Great North Road Solar & Biodiversity Park – EN010162
Carlton-on-Trent Parish Council – Reference number: [REDACTED]
Deadline 5 response

RE: RE: Water displaced by panels at Carlton-on-Trent

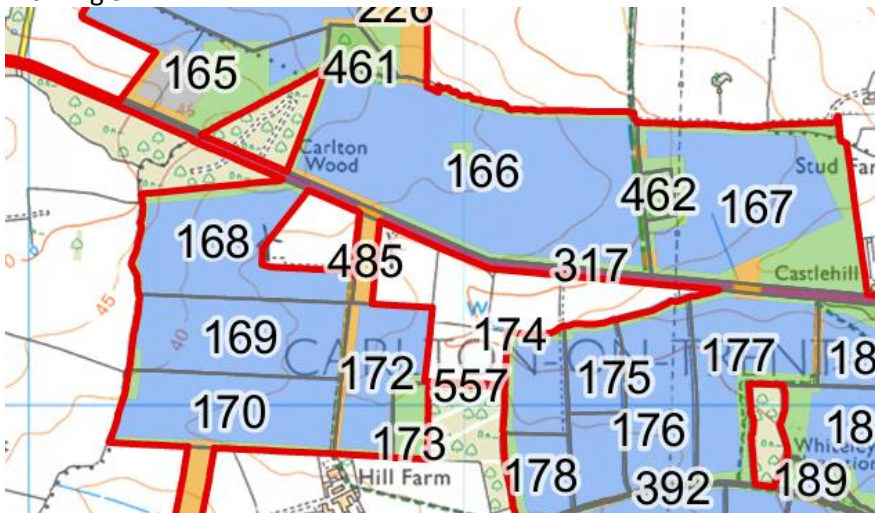
We had already identified which field you plan to put the substation, next to Carlton Wood, an Ancient Woodland.

Please provide specific dimensions, if this has yet to be confirmed please say so. We are trying to build up an understanding of the proposal and how it will impact on its immediate environment, hence why we ask about distance from the road and what screening is planned below.

This does not help to show where the cables will be coming from or going to. Is it possible to show with arrows? Orange 'cable' lines are disjointed, the line in the proposed substation field is not connected to anything, presumably this is covered by the red line. Could you please send us image 5.1 without the redline to help us understand proposed cable layout, with a better explanation please. This in turn will help to answer question 5 below.

If we have assumed correctly that cabling will go between the woods along the B1164, how do you propose to fit the trench here?

Cabling near the substation will be of significant size meaning trenches will be 30m wide, the road ranges in width between the woods from 4.7m to 5.2 at its widest. This is not wide enough forcing you to go along the roadside verges, cutting into the tree roots **AND into** the woods - which you have scoped out of the EIA and say will not be part of the project. To be clear the verges form part of the wood, they are not adopted by highways and belong to the estate.

The width of the areas between the woods and the road also varies on each side; the north 1.8m – 5.75m, and the south 4.7m – 6.75m. Total width ranges from 11.3m – 17.3m. No where is wide enough to take a 30m wide trench (the figure you sent us) and as you can see there are areas that will not accommodate the 12m trench either.
